Subject: PL/2023/07503 Variation of conditions 5, 6, 7 of 15/11604/OUT - OBJECTION

OBJECTION

Image: Extract 1 - extract of Headwall Relocation Plan 0654-SK-301-B dated 12-08-24

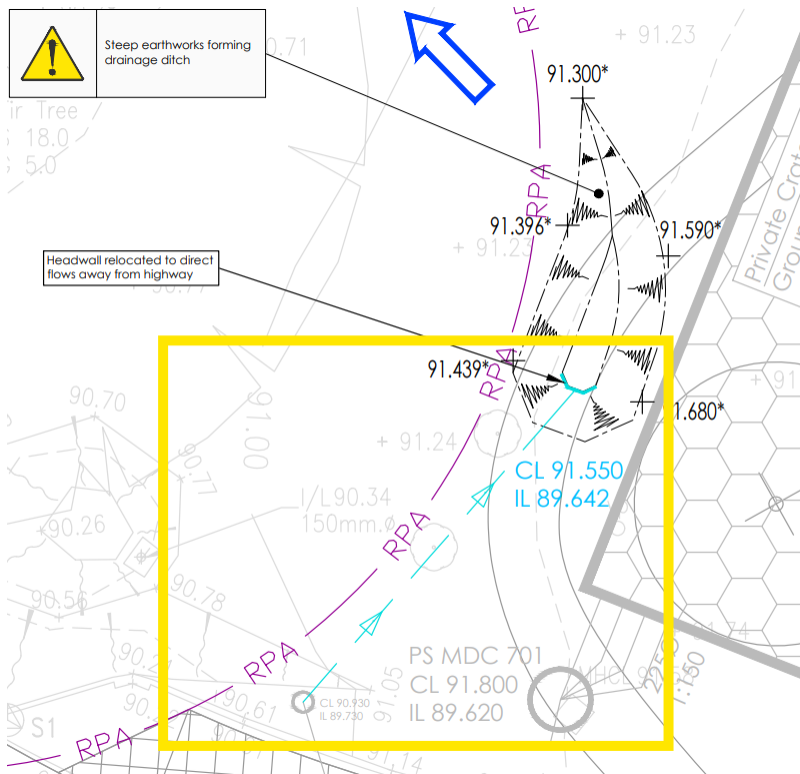
7. There has been no reason given why the land-drain and the headwall for the overflow were moved from the approved position. Although it is now proposed to move the headwall and overflow to higher up in the open space, and construct a new earthwork, will water flow uphill from the land drain's current position (shown in the yellow box in the image 'Extract 1' below)?

8. Although the LLFA requested on 05-08-24 details for how the unlawful basin within the RPA of the protected cedar tree will be filled, the Headwall Relocation Note proposes leaving it as is. Although the land drain would no longer be flowing into this, it will still fill with water during lengthy periods of intense rainfall, and then overflow down the road. the side of this basin is also clearly washing away, which will risk further damage to the RPA.

9. The ground in the area around the public art bench, and the new earthwork detailed in the Headwall Relocation note and plan, is heavy clay and quickly becomes waterlogged after even short periods of heavy rain. Is this really suitable ground conditions for natural infiltration?

Image: Extract 2 -extract of approved plan Preliminary Drainage Layout plan reference 0654-PDL-101-D dated 07-02-18, taken from approved Drainage Technical Note 0654 version D dated 07-02-18.

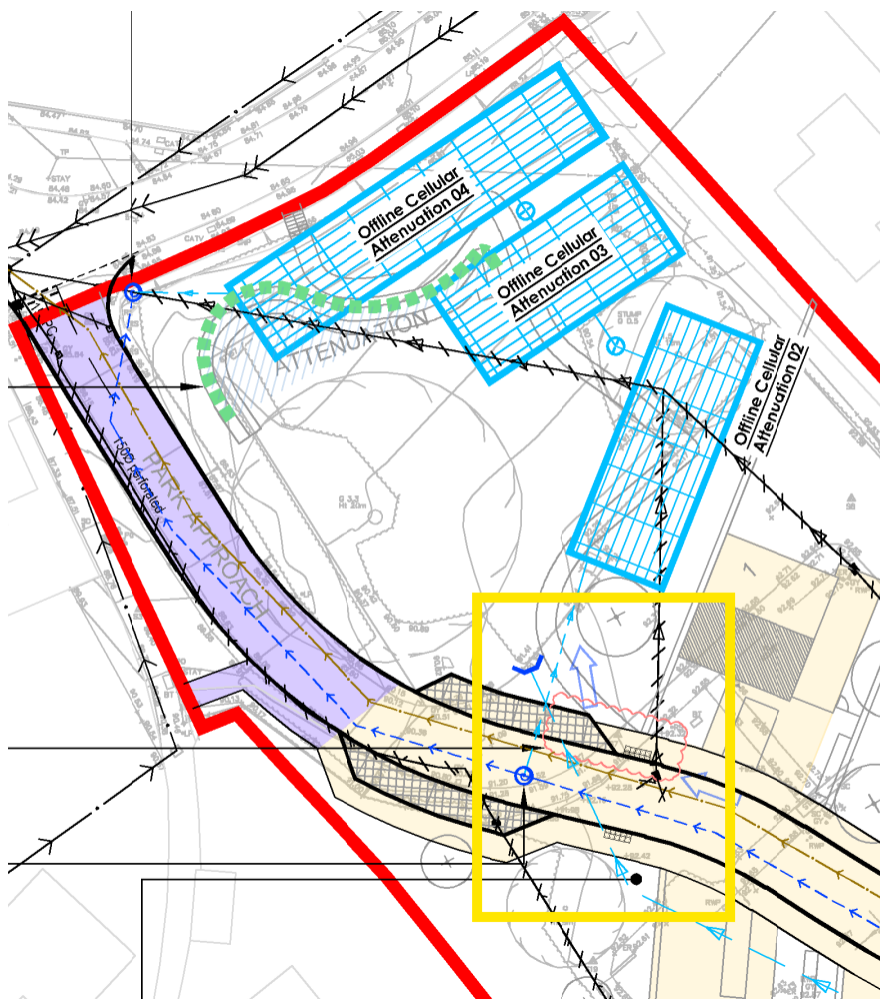
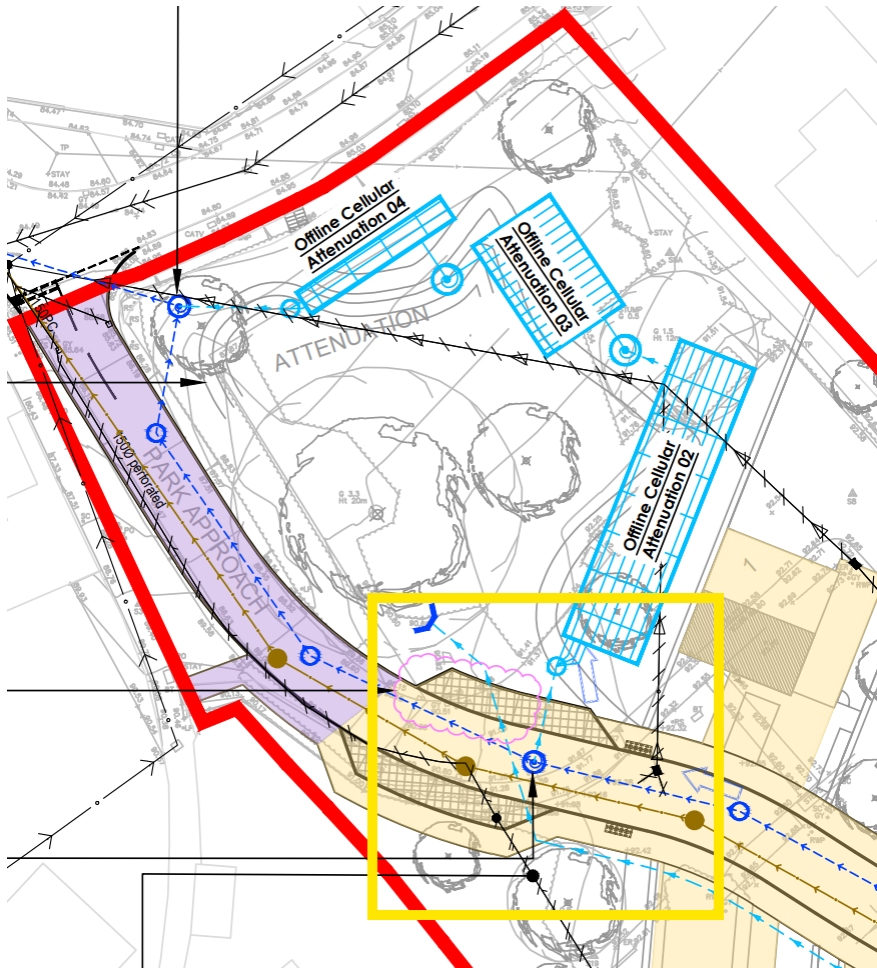
10. As the applicant has to re-build the headwall for the overflow, why are they not implementing the original approved scheme, by re-locating the land drain and headwall to the already approved positions (shown in the yellow box in the image 'Extract 2' below)? We assume this would also remove the need for new earthwork detailed in the Headwall Relocation note and plan.

11. The bunding at the site entrance, shown as green dotted lines on the image 'Extract 2' above, has not been built. Without this, the overflow from the land-drain will just run off the bank and onto highway at the Butts and then into the highway drains, albeit at a different point to currently.

13. There has been no reason given why the "combined kerb and drainage system" that is intended to "take exceedance flows off the carriageway and into the open space in the north-west corner of the site" were moved from the approved position (shown within a red cloud-like outline in Extract 2 above) to the bottom of the visitor parking bay (shown within a pink cloud-like outline in the image 'Extract 3' below). Unless water flows uphill, this could never work. However, as the kerbs in the visitor bay look just like normal kerbs, has this even been built?
